寄件者: WARREN WONG <[REDACTED]>
寄件日期: 2026年10月09日星期五 12:44
收件者: Adrian Tsz Hin TAM/PLAND
副本: Sheren Si Wai LEE/PLAND; Johnny Chung Yin LAM/PLAND
主旨: FI for S16# A/NE-TKL/844
附件: FS Proposal at Fung Kat Heung (Full Set) - Re -Submission- 2026.10.09.pdf;
Departmental comments Response (FSD) 2026.10 - TKL 844.pdf; Relacement Page 5 & 10.pdf

Planning Application No. A/NE-TKL/844
Temporary Warehouse and Open Storage of Construction Materials with
Ancillary Facilities and Associated Filling of Land for a Period of 3 Years

Response to the comments of Fire Services Department (FSD)
(as at 9 Sep, 2026)

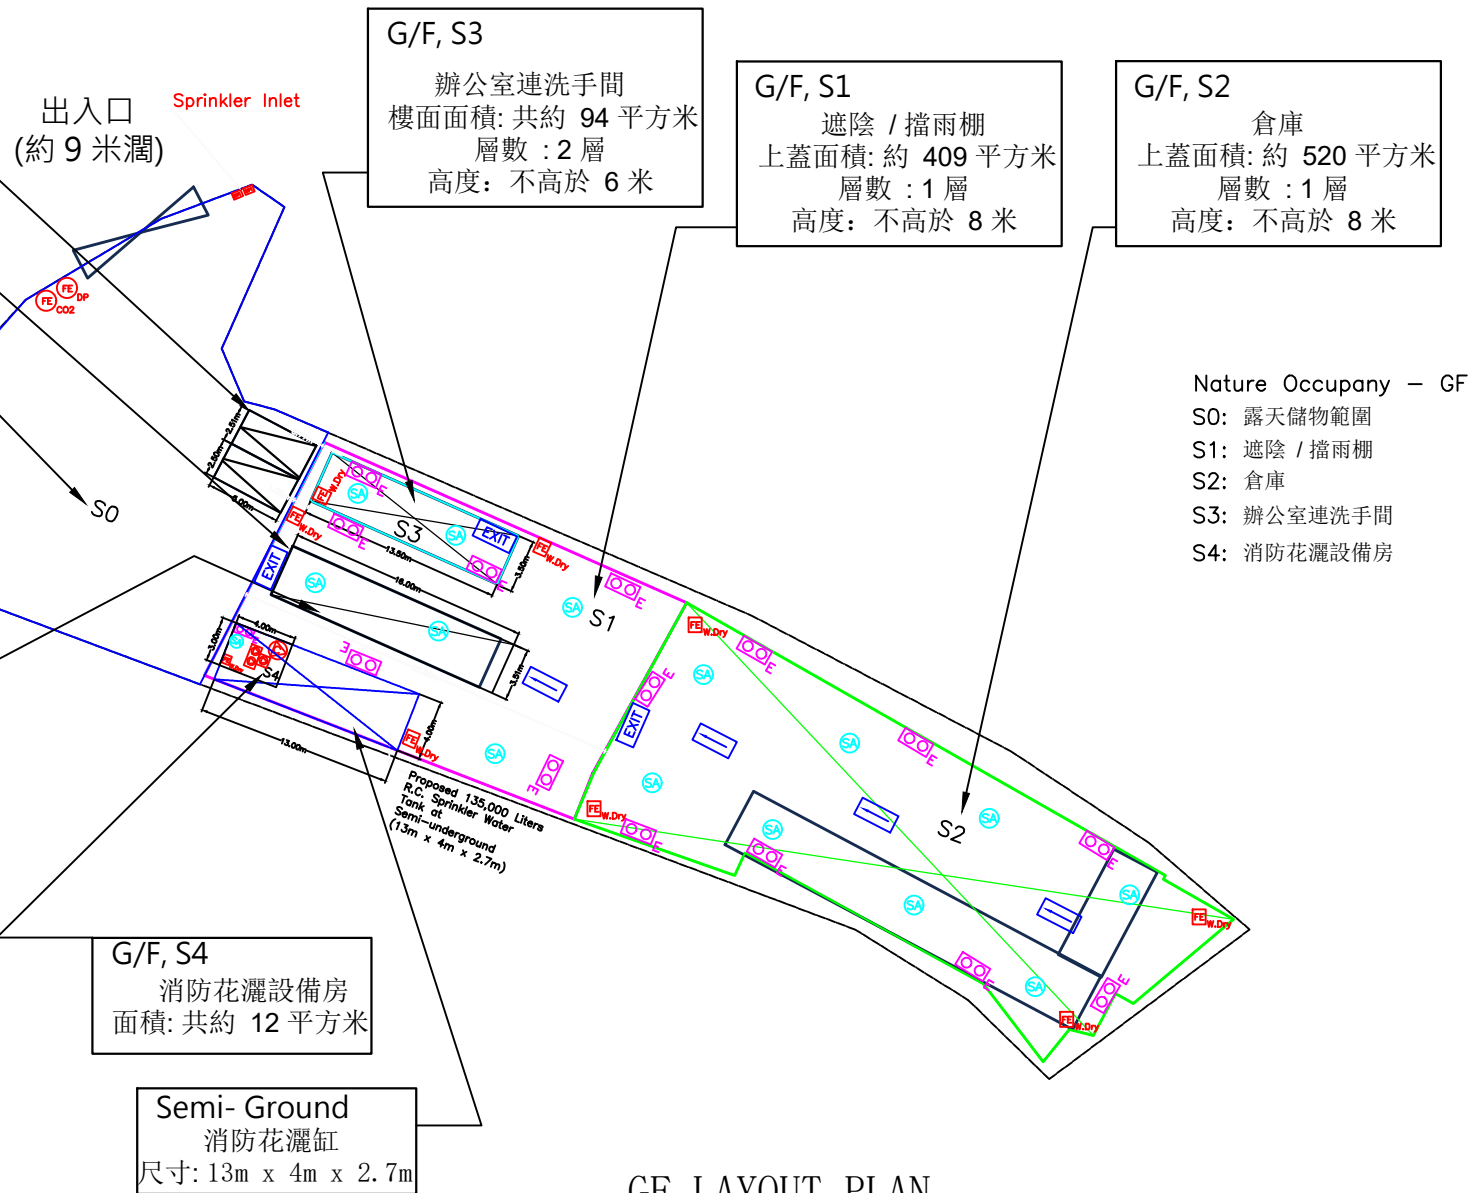
- structures on the same site are regarded as adjoining structures if they are less than 1.8m apart. In this regard, Structure S1 shall also be considered as the adjoining structure for Structure S2;

- for structures with a gross floor area exceeding 230m² (including Structure S1), wheeled-type dry chemical fire extinguishers, sprinkler system, emergency lighting, directional and exit signs and stand-alone fire detectors shall be provided for every structure;

- as the applied use is a warehouse, storage configuration, category, height, storage area of a single block and the clearance around the block shall be clearly indicated in the FS notes;

- for every area designated for open storage, a suitable type of portable fire extinguishers shall be provided in accordance with the formula: Storage area(m²) x 0.003; and shall be located in a prominent position that is easily accessible to both staff and the public within the open storage area;

- the area designated for open storage shall be demarcated on the plans; and
- the applicant should clarify the use of Structure S4 (i.e. whether it is a sprinkler pump room or an office).

消防建議書已更新，請參考附件

"FS Proposal at Fung Kat Heung (Full Set)-Re-Submission-Oct.2026"
